Proposal to amend document ECE/TRANS/WP.29/GRSP/2020/8

(Proposal for the 10 series of amendments to UN Regulation No. 17
(Strength of seats))

Submitted by the expert from the International Organization of Motor Vehicle Manufacturers

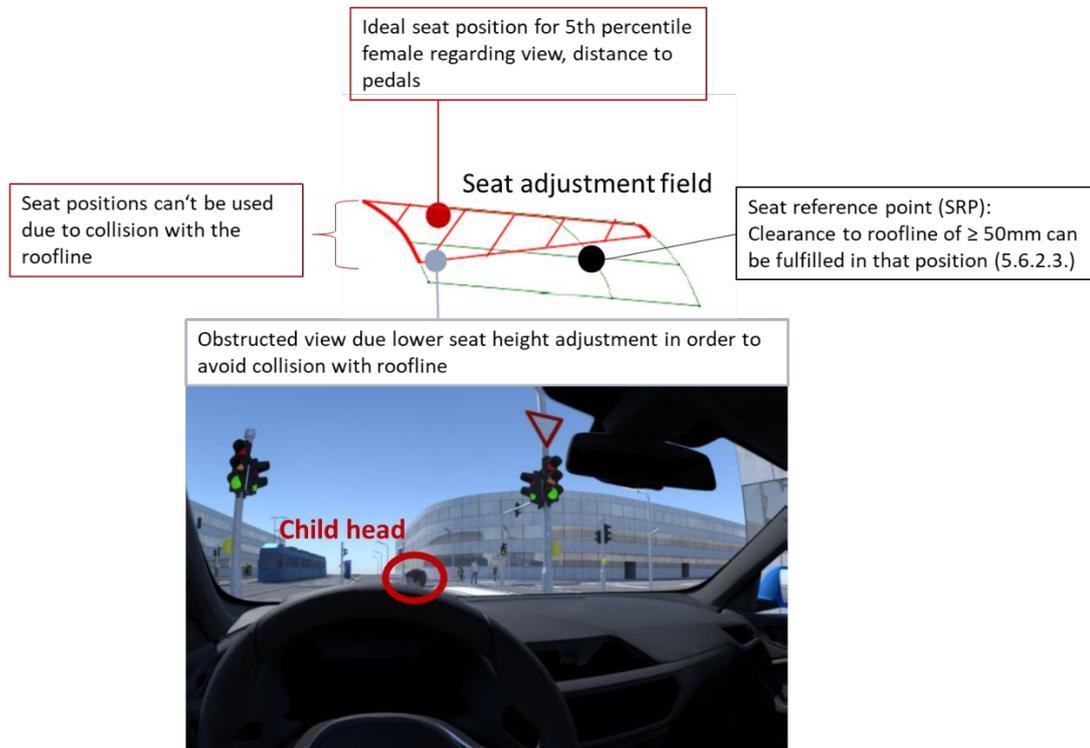
If the interior surface of the vehicle roofline, including the headliner, physically prevents a head restraint, located in the front designated seating position, from attaining the height required by paragraph 5.6.2.1. or 5.6.2.2. of this Regulation as applicable, the gap between the head restraint and the interior surface of the roofline, including the headliner, when measured in accordance with Annex 10. paragraph 2.3.3.1., shall not exceed 50 mm when the head restraint adjusted to its highest position intended for occupant use.

In case of seats fitted with integrated head restraints that cannot be adjusted in height and the head restraint would interfere with the roofline in at least one seat adjustment intended for normal occupant use, the clearance in this seat adjustment shall not exceed [10] mm. If this leads to a gap of more than 50 mm when measured in accordance with Annex 10. paragraph 2.3.3.1., then the head restraint shall conform to the requirements of paragraph 5.6.1.1.2.

It is assumed that smaller people (e.g. 5th percentile woman) will use the highest seat adjustment position with a more upright backrest on the driver seating position. In some vehicles with specific rooflines and seats fitted with integrated not height adjustable head restraints this can lead to a contact with the roof.

For these reasons, OICA suggests that in case of low roofline and seats fitted with integrated not height adjustable head restraints the exception rule shall be applied if there is at least one seat position affected.
